YALYALUP Mineral Sands Project

ENVIRONMENTAL REVIEW DOCUMENT- RESPONSE TO SUBMISSIONS, V4

EPA ASSESSMENT NO: 2141

Document Ref: DMS-YAL-ERD-RTS-004-V4

FIGURE 1: REVISED CLEARING AREA – YALYALUP RD

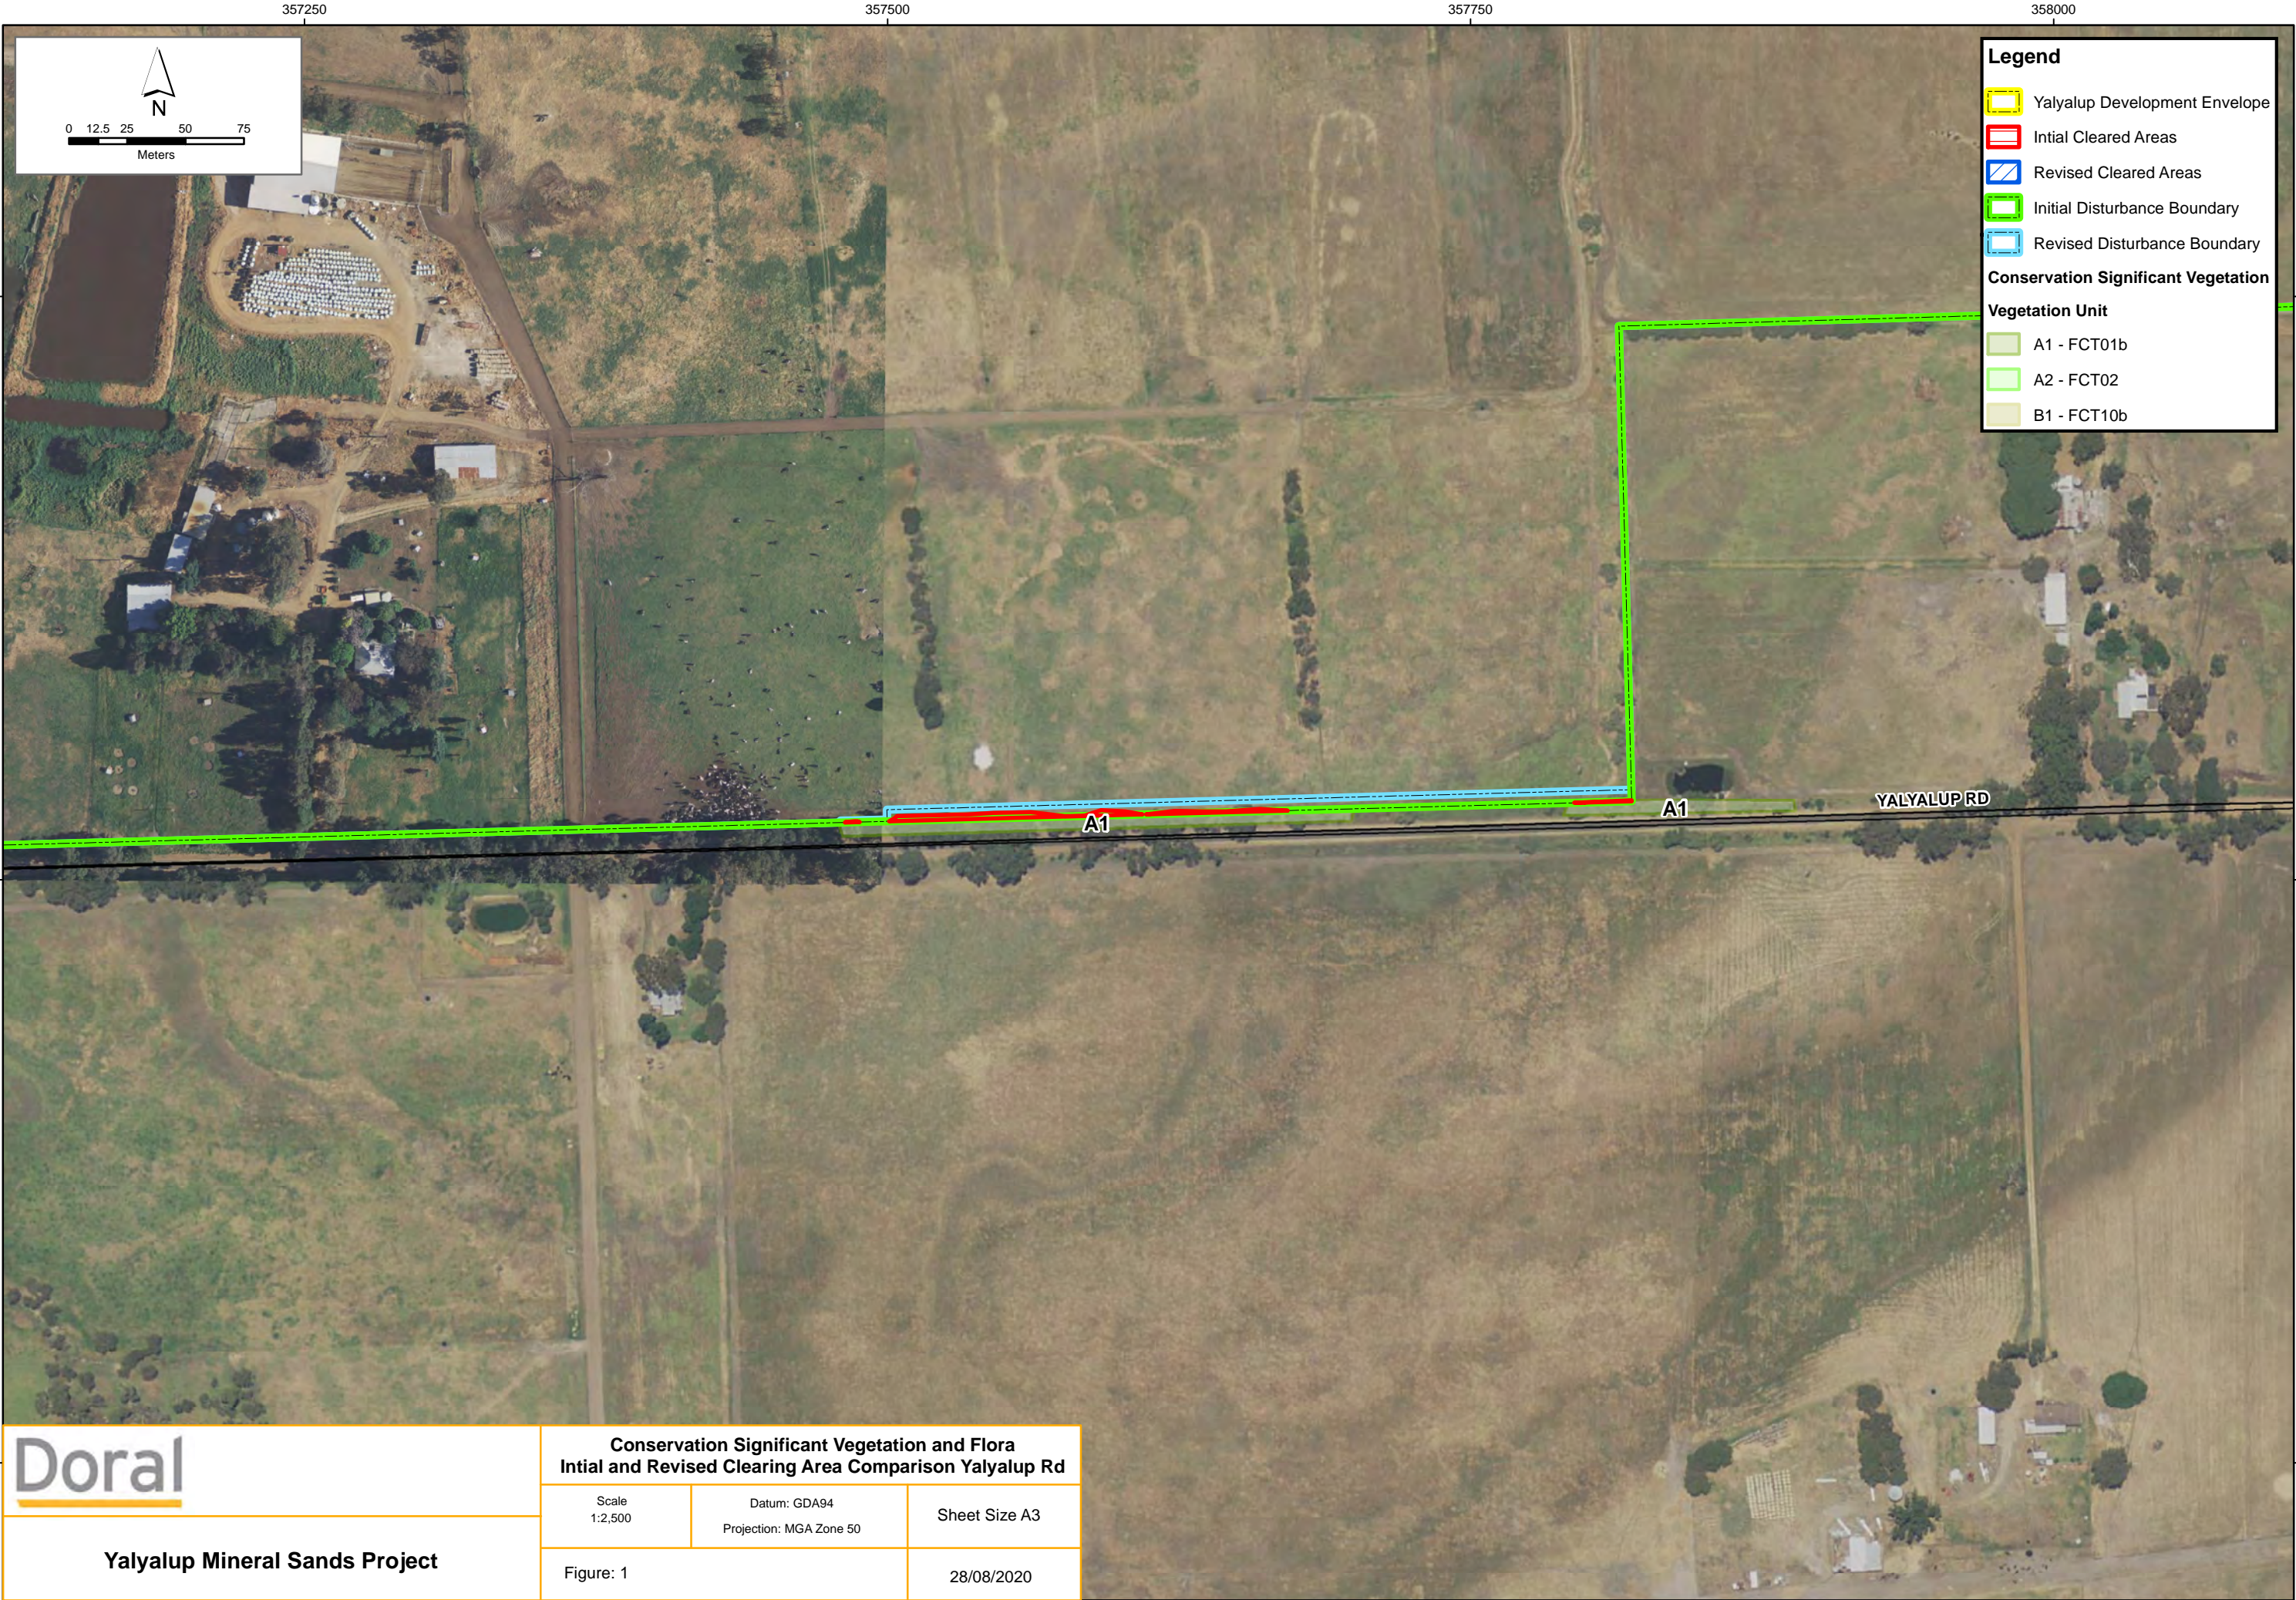
DBCA	<p><i>Recommendation 1:</i> <i>That if the proposal is considered acceptable, a condition of approval is applied that requires the development and implementation (and regular review) of a conservation significant flora and vegetation management plan that specifies the approved limits of impacts, objectives and monitoring protocols to identify and manage conservation significant flora, vegetation, communities and their habitat.</i></p> <p>Discussion: Threatened flora (and their habitat) and TECs are known to occur within the development envelope and within the area of predicted groundwater drawdown. The ERD (e.g. Tables 4-12, 4-13, and 4-14) and supporting appendices present details on the conservation significant values that are predicted to be directly or indirectly impacted by the proposal. However, there is some uncertainty in:</p> <ul style="list-style-type: none"> Verification of the mapped extent of TEC SWAFCT10b 'Shrublands on Southern Swan Coastal Plain Ironstones (Busselton Area)' (ranked critically endangered); TEC SWAFCT02 'Southern wet shrublands, Swan Coastal Plain' (ranked endangered); and TEC SWAFCT01b '<i>Corymbia calophylla</i> 	<p>Discussion acknowledged.</p> <p><u>Recommendation 1</u></p> <p>DIRECT IMPACTS</p> <ul style="list-style-type: none"> Doral have prepared a Flora and vegetation Management Plan which includes development and implementation of specific clearing procedures to minimise any inadvertent direct impacts to flora and vegetation, including conservation significant flora and vegetation. This includes demarcation of vegetation/trees to be cleared and authorisation requirements prior to any clearing activity being conducted. Monitoring requirements have also been defined and include rationale of monitoring site selection, baseline monitoring, frequency of monitoring, monitoring methodology and management response triggers and

FIGURE 2: REVISED CLEARING AREA – MCGIBBON TRACK

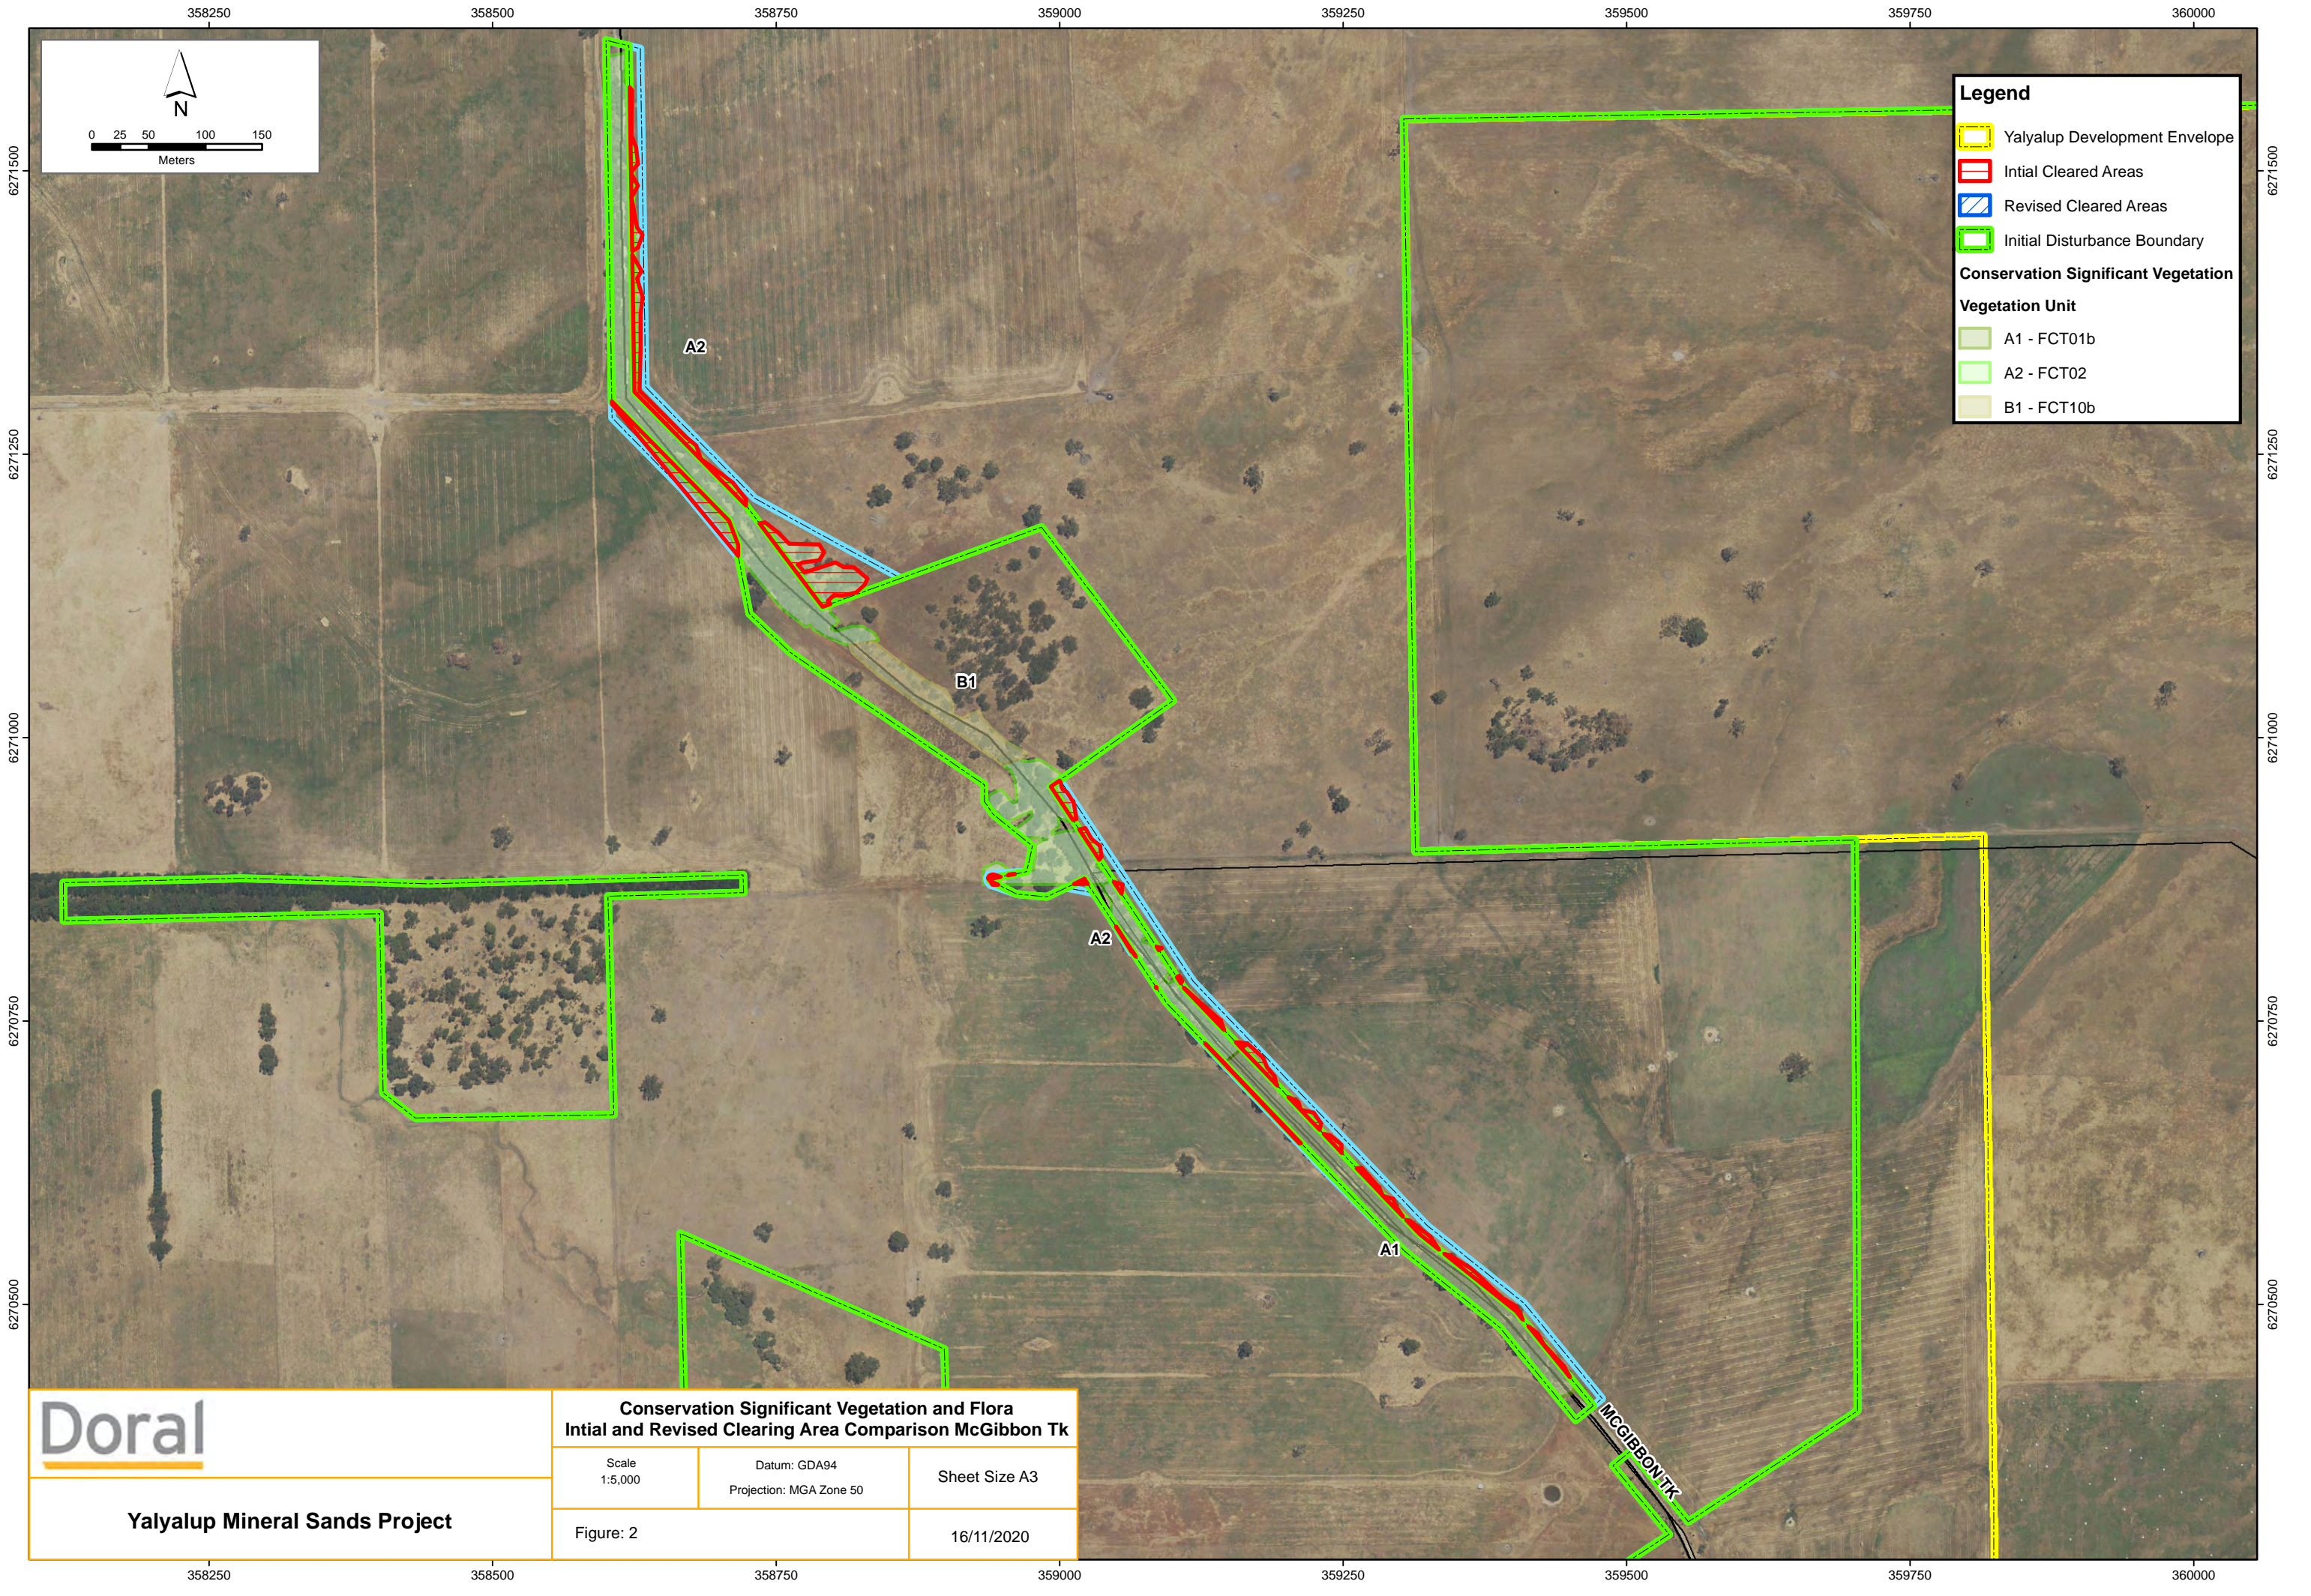
SUBMITTER	SUBMISSION AND/OR ISSUE	RESPONSE TO COMMENT
Southwest Catchments Council	<p>2. Threatened Fauna Impacts</p> <p>The potential for the abstraction of groundwater to impact on native vegetation on the nearby McGibbon Track and Sabina River needs to be closely monitored. These areas have been identified as important ecological linkages and an important corridor area linking western ringtail possum populations from the coastal plain through to the forested areas on the Darling Scarp. Any impact on these areas needs to be closely monitored over the life of the project and mitigation measures implemented if needed to ensure that these areas are not degraded because of the development.</p> <p>The ponds created as part of the mining process may become used as water sources by black cockatoo species. The use of these ponds by these species should be monitored so that the impact of their removal at the end of the mine's life can be managed in such a way as to avoid any negative impact on these threatened species. If their use becomes significant, consideration should be given to retaining some of the water bodies during the rehabilitation of the site if possible.</p>	<p>Acknowledged</p> <p>A GDE Management Plan has been prepared by AQ2 (2020c) to document Doral's proposed mitigation measures for potential drawdown impacts on groundwater dependent vegetation and is provided as Appendix 4E of the ERD. The GDE Management Plan has since been revised (October 2020 Version C) in consultation with DAWE and DBCA to remove the point intercept method and increase the frequency of vegetation health quadrat monitoring. The revised version is provided in Attachment 1 of this document.</p> <p>Doral has prepared a Fauna Management Plan which includes management and monitoring procedures to mitigate risks to fauna from temporary open water bodies. This Management Plan has been provided to EPA/DAWE for assessment.</p> <p>Doral notes that no evidence to date of usage by fauna (Black Cockatoo) within the production dam or other open water bodies at the Dardanup or Yoongarillup Mine sites has been observed.</p> <p>Several other nearby natural permanent water bodies (Sabina River and Abba River) are in close proximity to the proposal and can continue to be used by Black Cockatoos prior to, during and after implementation of the Proposal.</p>
